AGENDA
HAYDEN PLANNING COMMISSION
THURSDAY, JUNE 9, 2022
7:00 P.M.
HAYDEN TOWN HALL – 178 WEST JEFFERSON AVENUE, HAYDEN

AGENDA ITEM TITLE: Public Hearing: 112 West Jefferson
Site Plan Review
Woodruff Flats

APPLICANT: Brinkman Properties, LLC; representative Axial Arts, LLC

1 SITE & LANDSCAPE PLAN
A1.0 1/8"=1'-0"

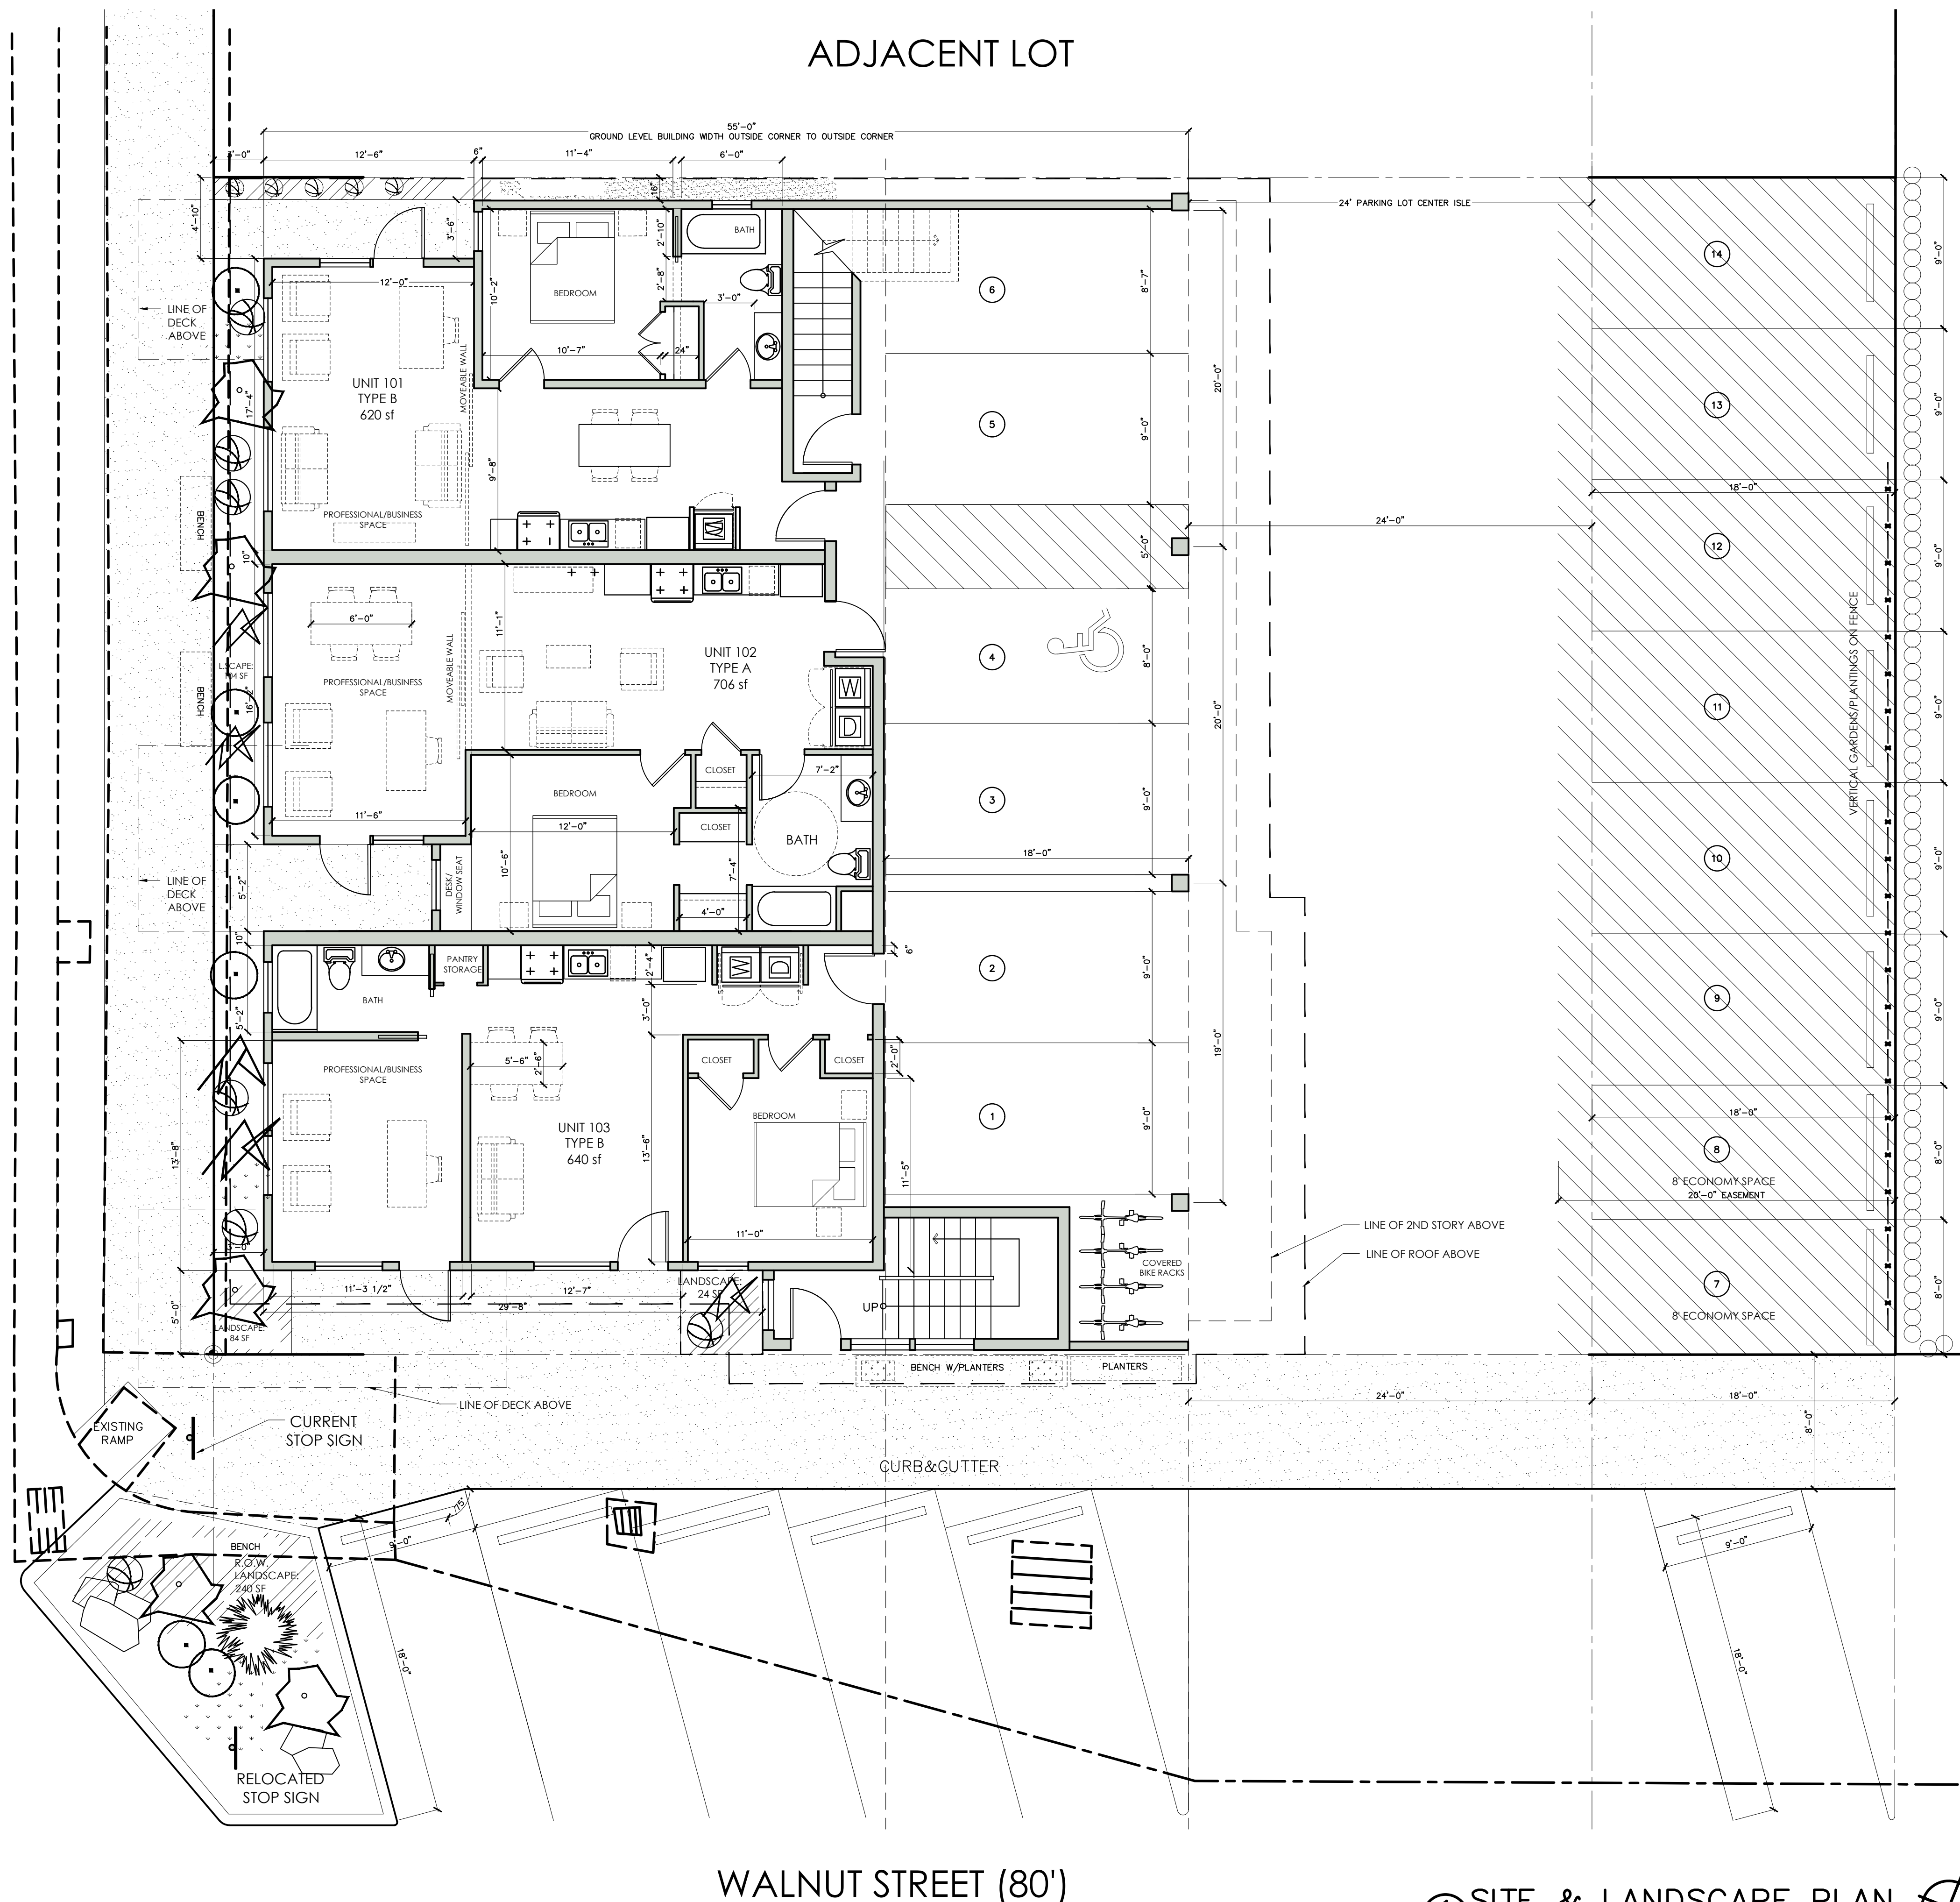
Complies Yes	No	Section Standards
		(b) General Provisions. In all zone districts, off-street parking facilities for the storage of motor vehicles for the use of occupants, employees and patrons of the building or structures hereafter erected, altered or extended shall be provided and maintained as herein prescribed.
√ _____	_____	(11) <u>Adjacent on-street parking in the CBD: Central Business District.</u> In order to promote a pedestrian scale and encourage a perception of safety in the CBD: Central Business district, parking for other than residential or overnight uses may be satisfied using adjacent on-street parking or shared rear-lot parking areas. A parking study and shared parking agreements shall be used to demonstrate the adequacy of the parking supply as a substitute for standard parking requirements. <i>Staff comment: The site plan shows N Walnut adjacent to the lot</i>

being used to satisfy required parking. This parking area is non-exclusive/non-overnight.

- (1) Paved off-street parking shall be provided according to the minimum requirements as specified: Apartment dwellings: 1 space per bedroom, up to 2 per unit; **Staff comment:** *The apartment complex requires 15 spaces however 14 are being proposed onsite along with bicycle parking. The applicant is proposing the improvement of N Walnut Street adjacent to the site and the installation of 6 additional parking spaces for non-exclusive/non-overnight use. Each apartment unit has one dedicated parking space onsite. Staff support the proposed parking plan due to the overall benefit to the public of the improved right-of-way parking, the proximity to the regional transit bus stop, and the promotion of compact urban growth in the core of the Town. A condition is recommended below that requires that the 14 onsite parking spaces and the 6 offsite parking spaces be paved. Hayden Public Works and Hayden Police Department were involved in discussions regarding parking and the proposed plan is supported by both.*

- (2) Off-street parking for commercial uses shall be sufficient to provide parking for employees of all proposed uses as well as long-term customer parking. Spaces reserved for employees shall be designated as such by means of striping and signage. Parking shall be located at the rear and sides of buildings to the greatest extent possible and screened from the view of streets as provided in this Chapter. Required parking in the CBD: Central Business district can be met with on-street and shared parking for other than residential or overnight uses. **Staff Comment:** *The first-floor space that can serve as professional office/small retail space is integrated within the proposed apartments on the same floor. The parking for the employee of that space is the same as the residential parking space. The right-of-way parking on N Walnut Street is adequate to accommodate commercial activities in those spaces.*

- (4) Number of handicap parking spaces: Total parking spaces in lot: 1-25: 1 space required. **Staff Comment:** *A van accessible parking space is proposed to be provided.*

Complies		Section	Standards
Yes	No		
		(b)	General Provisions.
<u>√</u>	_____	(2)	<u>Sidewalks required.</u> In all zone districts, except for the O district, sidewalks are required along both sides of a street. <i>Staff comment: Sidewalks already exist on the south side of the lot and the applicant is proposing sidewalks along the east side of the lot.</i>

2. The fourteen (14) parking spaces shown on the subject property and six (6) adjacent parking spaces located on N Walnut Street shall be paved.
3. The landscaping, improvements to the N Walnut Street right-of-way, and sidewalk shall be installed prior to the issuance of any Certificate of Occupancy (TCO/CO) or a financial guarantee and associated agreement shall be provided.

2 EAST EXTERIOR ELEVATION
A3.2 1/4"=1'-0"

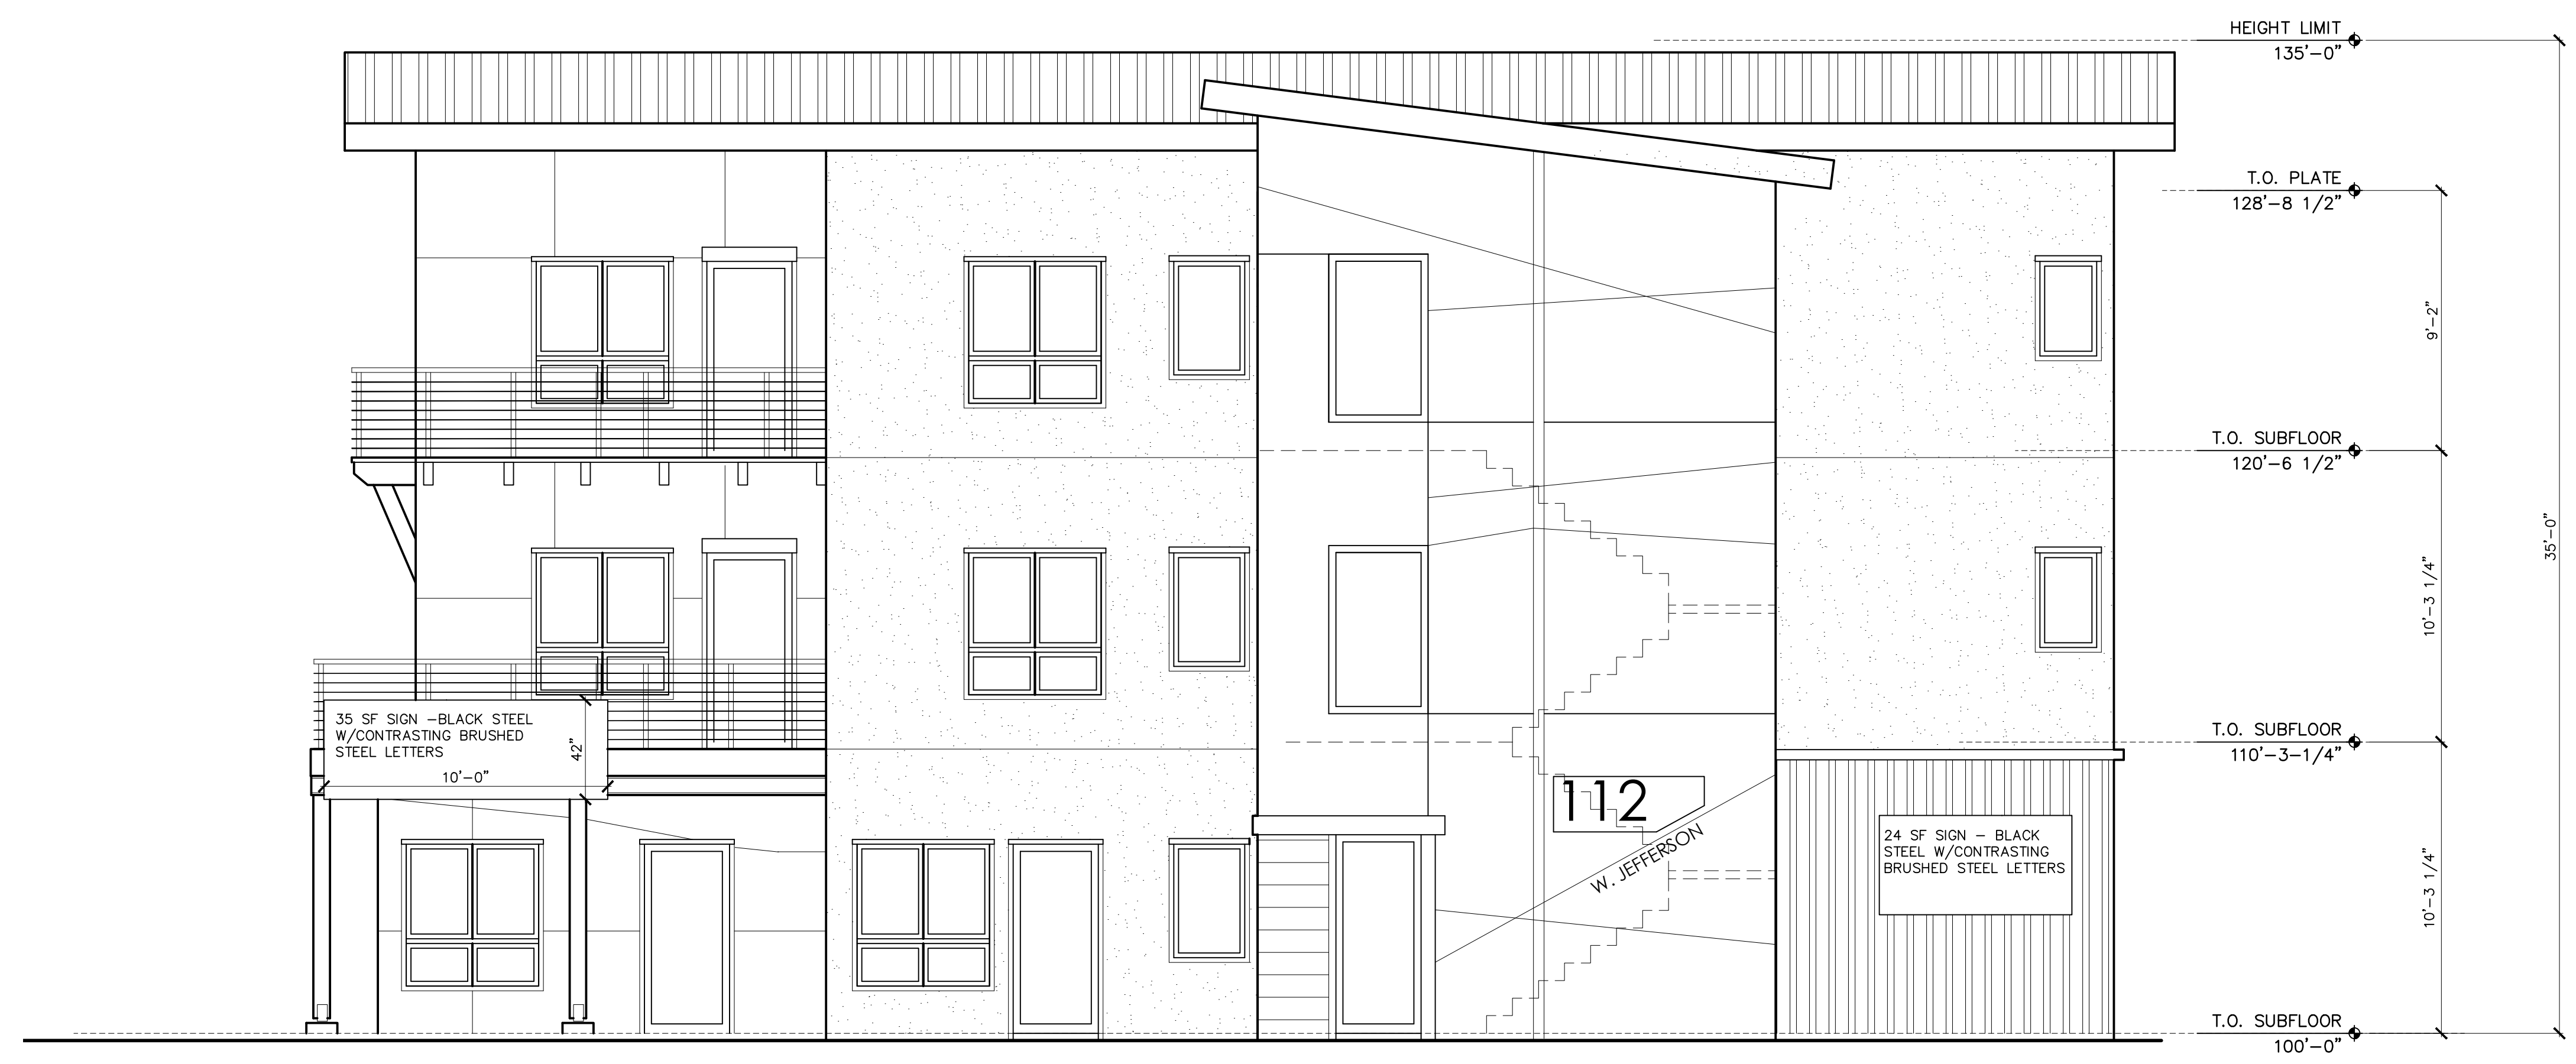
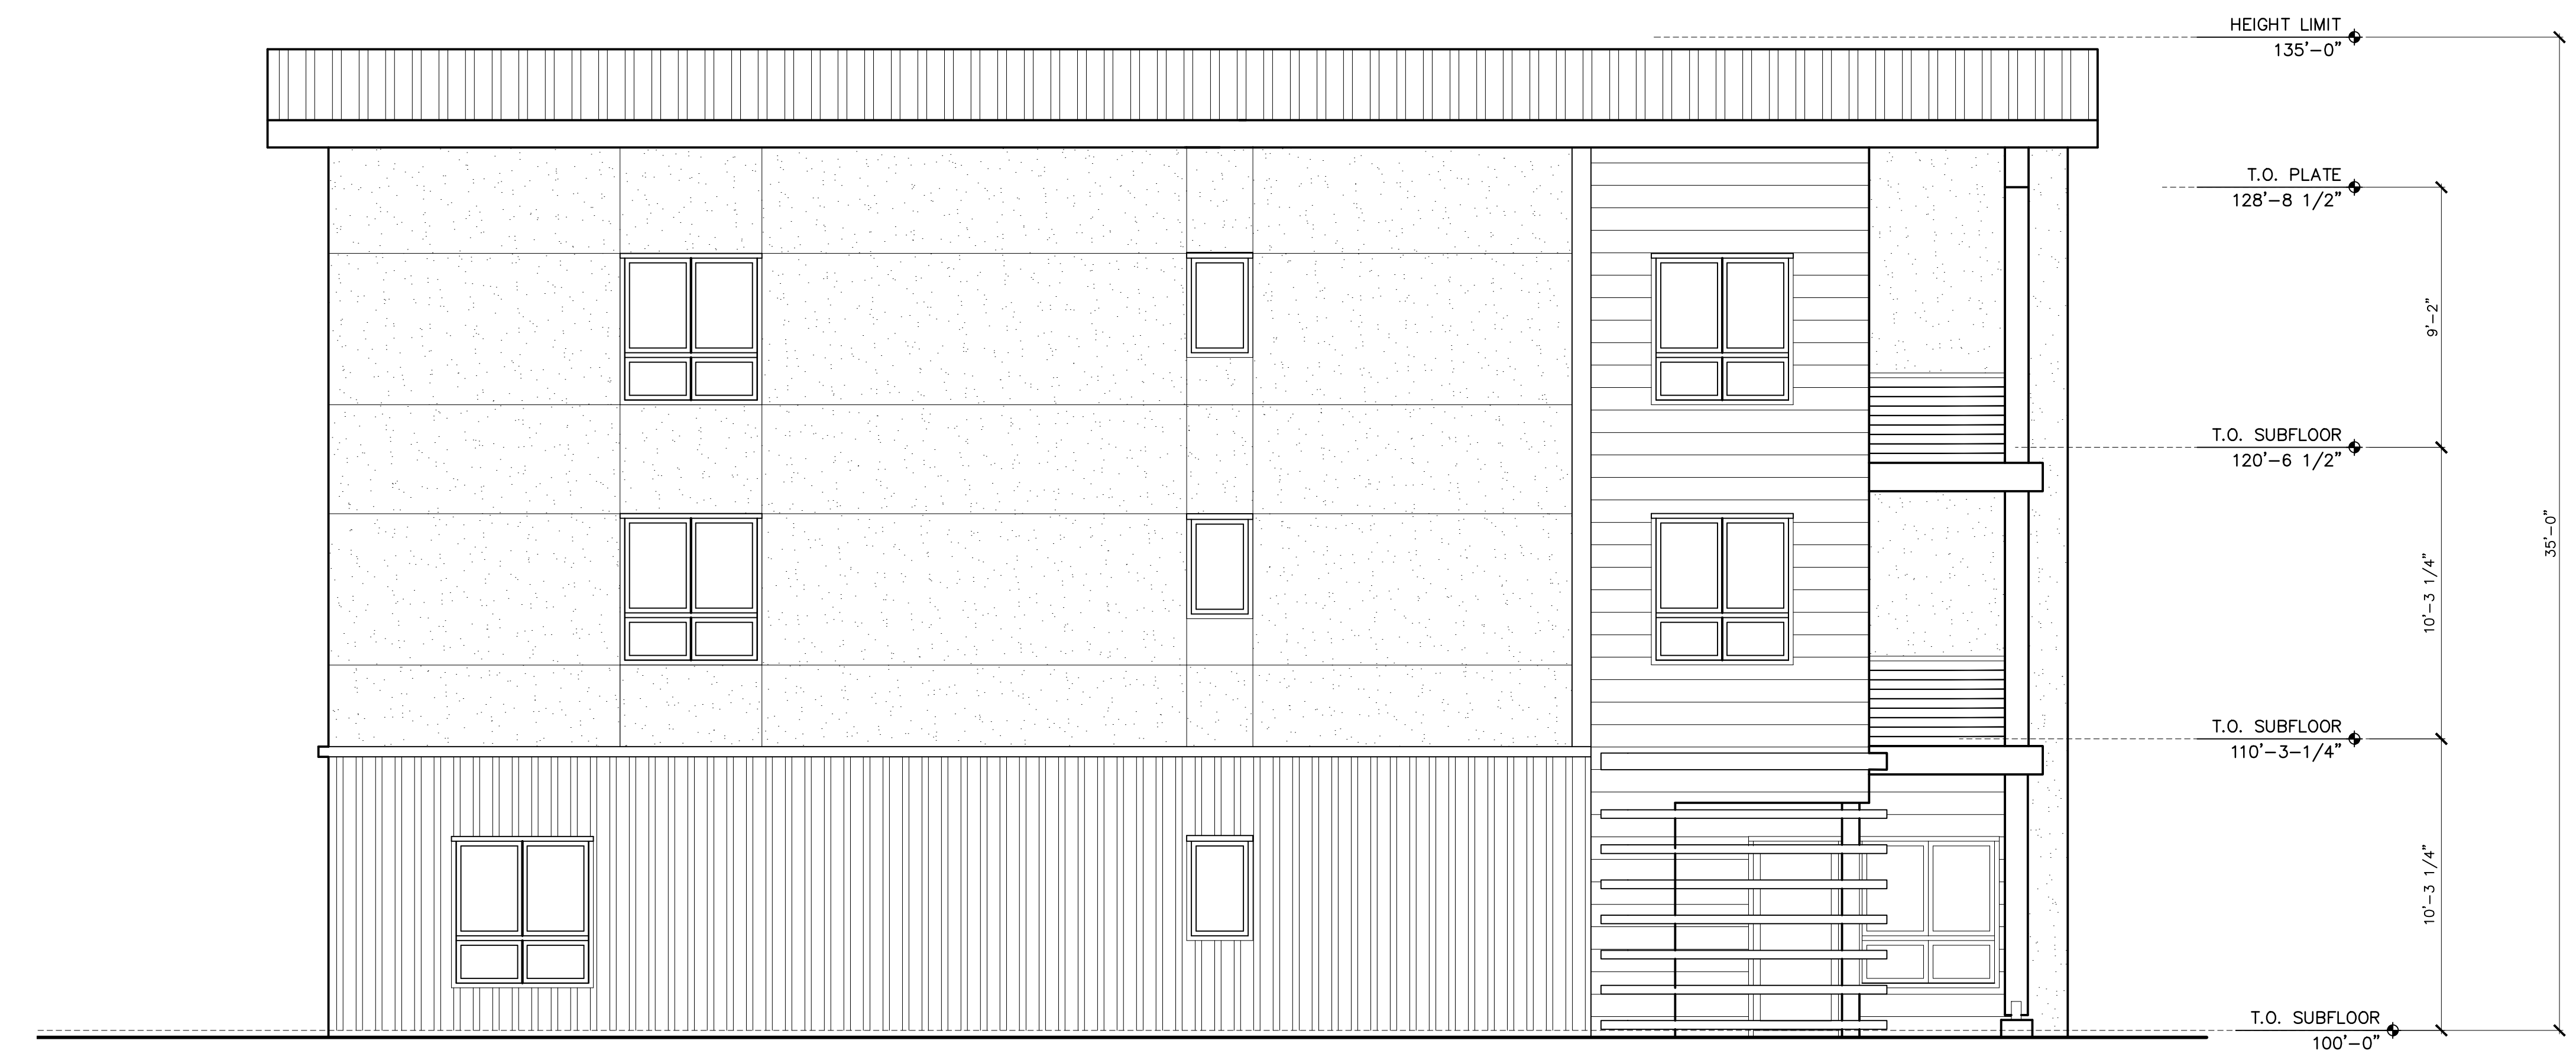
Complies		Section	Standards
Yes	No		
_____	_____	(c)	CBD: Central Business District architectural standards.
√ _____	_____	(2)	<u>Multi-story, mixed-use structures.</u> Commercial uses shall be contained in multi-story (two or three stories) mixed-use structures with commercial/retail uses on the ground level and above and/or apartment dwellings or offices on the upper levels. Such building shall vary in terms of footprint and architectural elevation. <i>Staff Comment: The applicant is proposing commercial/retail space on the first floor in the portion of the structure that frontages on Jefferson Avenue with residential space on the first-floor area that faces the parking area. The second and third floor are entirely devoted to residential space. The commercial/retail spaces have access off of the sidewalk on Jefferson Avenue with parking on N Walnut Street.</i>
√ _____	_____	(3)	<u>Entries.</u> Transparent entries and large store-front windows are strongly encouraged. Recessed and other styles of window openings are desired.

like shall be fully recessed. *Staff Comment: A condition of approval has been recommended pertaining to lighting standards.*

6. Evidence of a dumpster/recycling agreement will be provided to Town Staff prior to issuance of a any Certificate of Occupancy.
7. Lighting must be downcast and opaquely shielded.
